PRELIMINARY DETERMINATION

PERMIT RENEWAL AND MODIFICATION

City of Oxford Landfill
Permit No. 08-08

Subject: Request for Solid Waste Disposal Permit Modification
Landfill Sequence of Fill Update
City of Oxford Landfill
Solid Waste Disposal Facility Permit No. 08-08

CADD FILE: PHASE I BASE GRADE - V3
DATE: MARCH 2024
DRAWING NO. 05
SHEET 05 of - 09

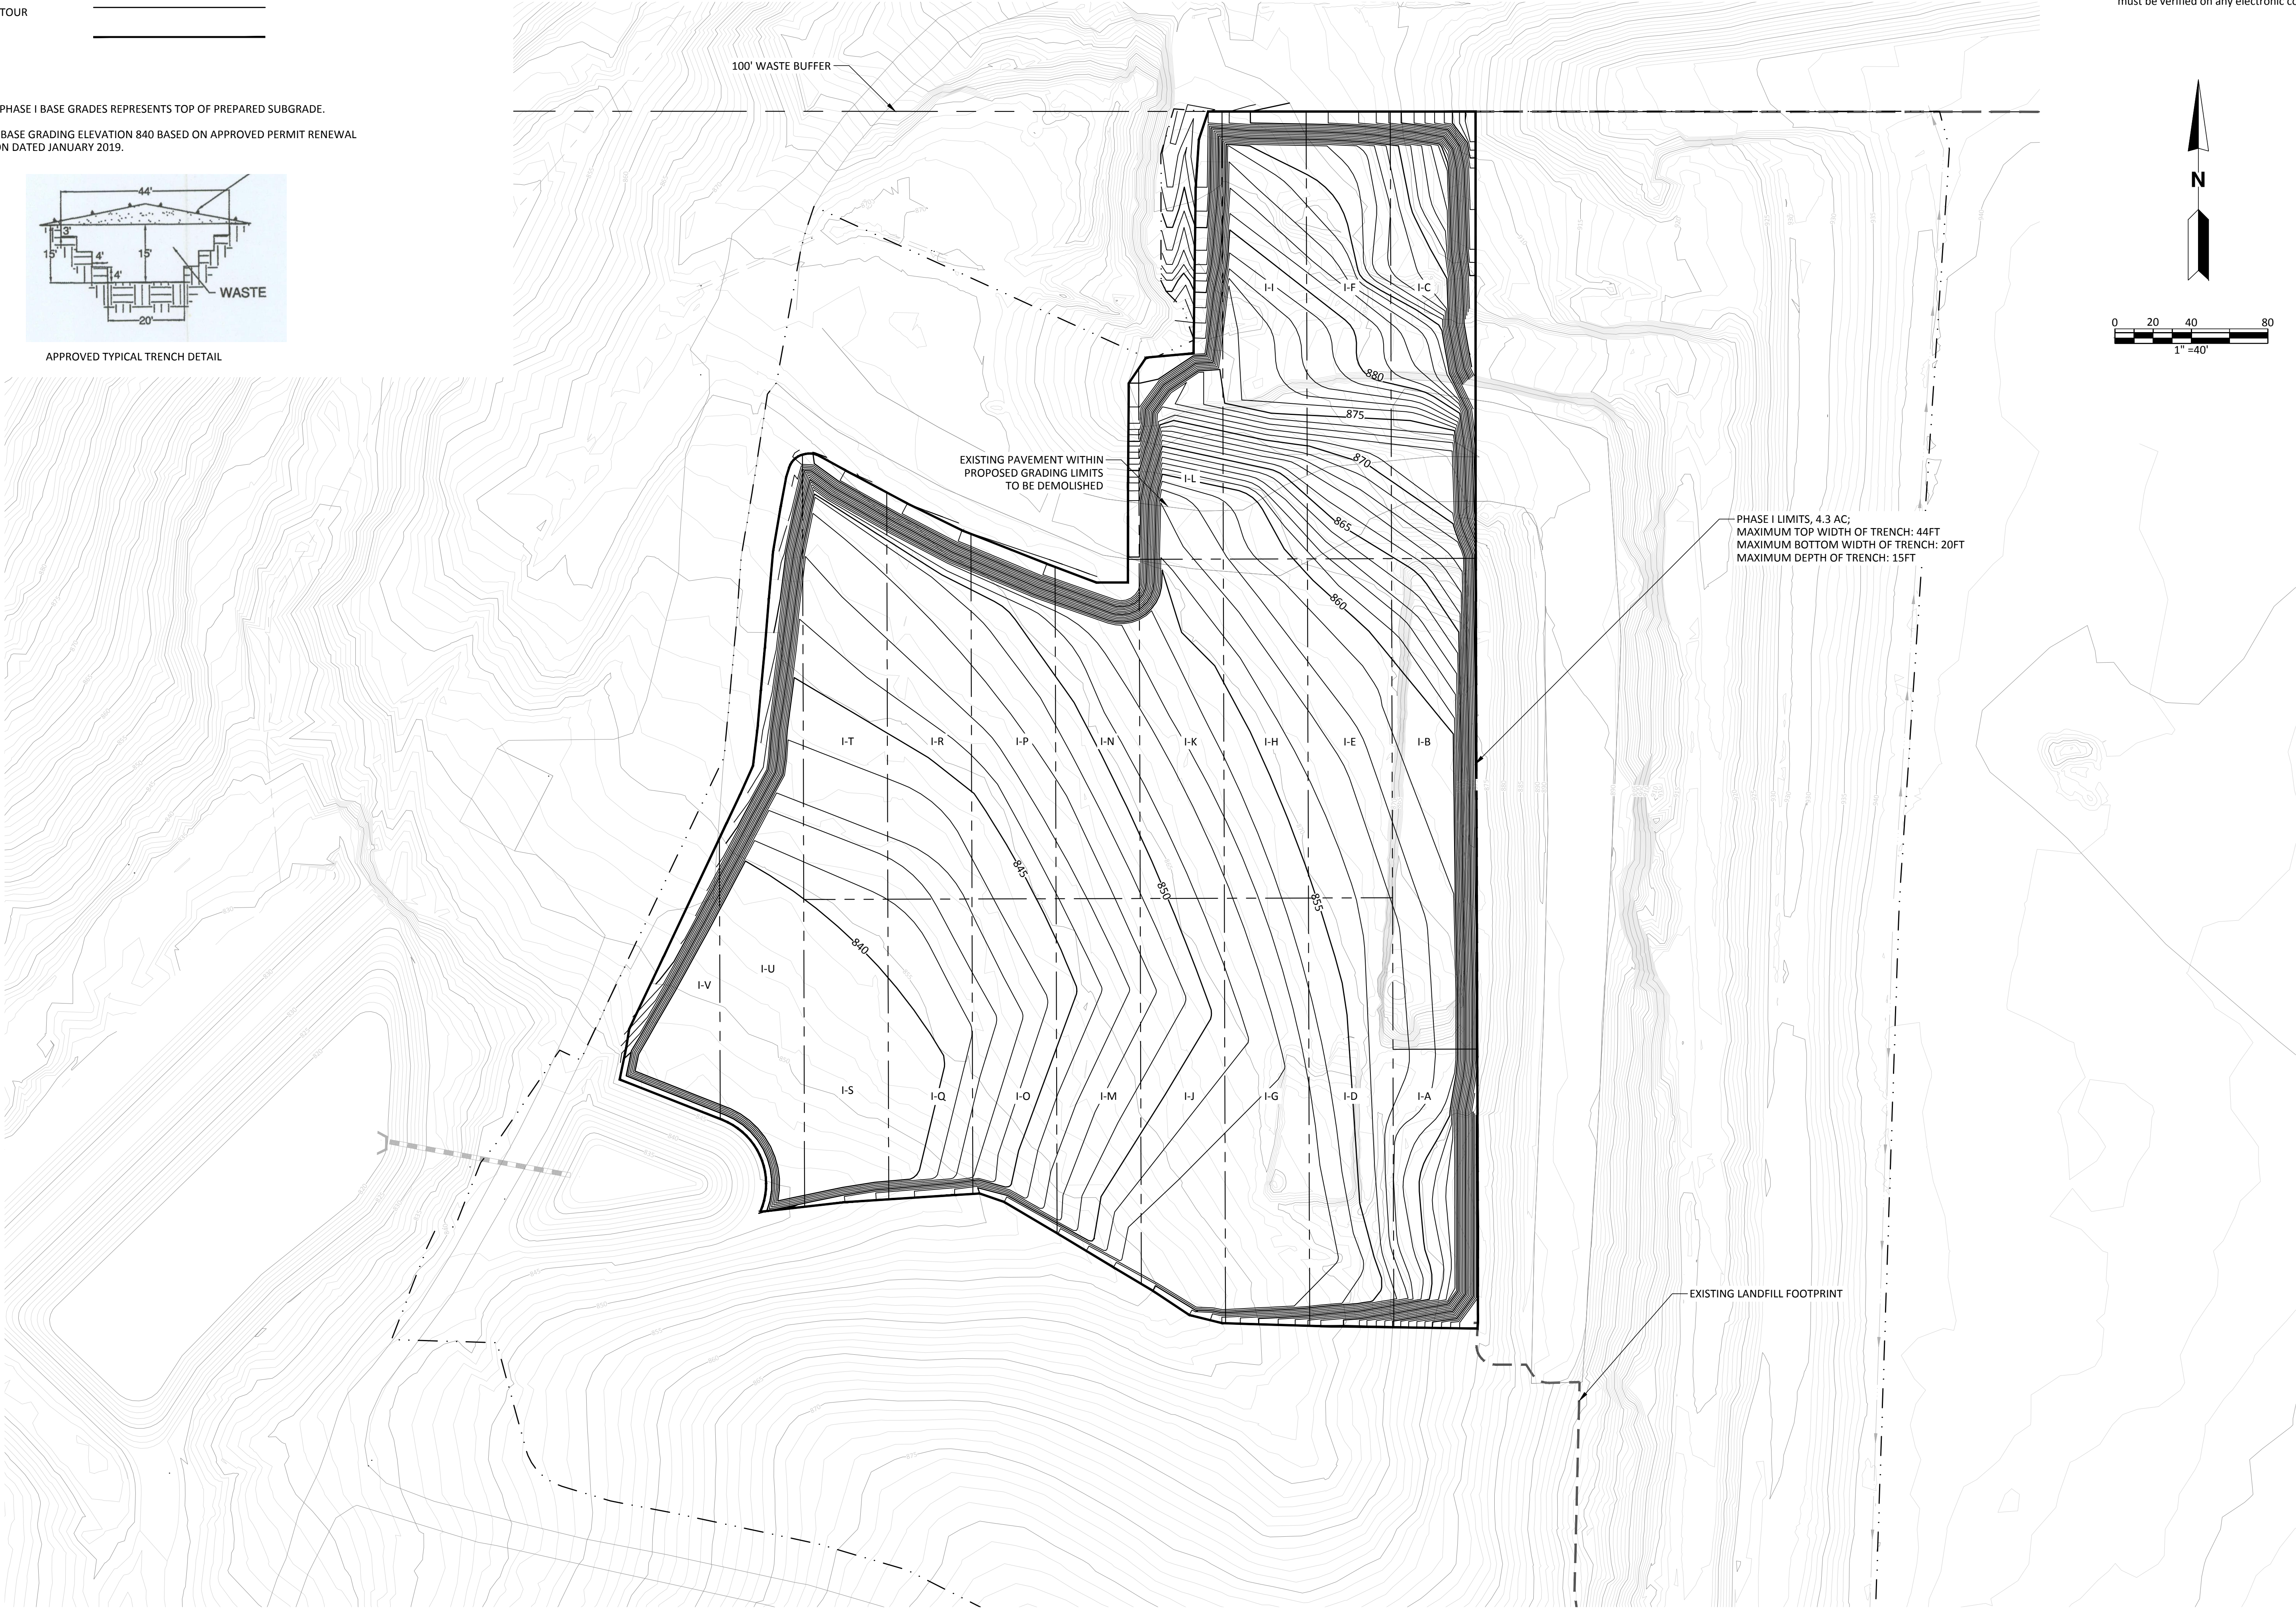
Based on comments received by you on the pending permit modification for the Oxford Landfill, attached is the revised drawing set. Sheets 05 and 07 (Base Grading Plans for Phases I and II) have been revised to ensure a minimum ten-feet of separation between the bottom of the landfill and groundwater. The cell layout of Phase I has also been adjusted to allow for smaller cell areas.

06
SHEET **06** of - **09**

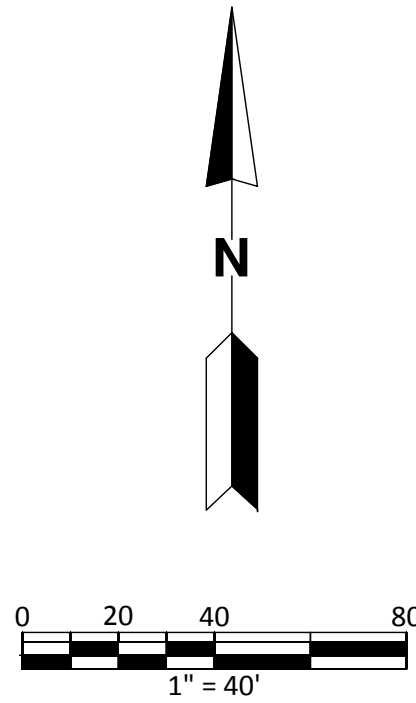
- Please submit Phase I Final Grading Plan (Drawing No. 6), Phase II Final Grading Plan (Drawing No. 8), and Phase III Final Grading Plan (Drawing No. 9) combined on one drawing. Please also provide a drawing or explanation as to what part of the permitted facility that these design plans are for.
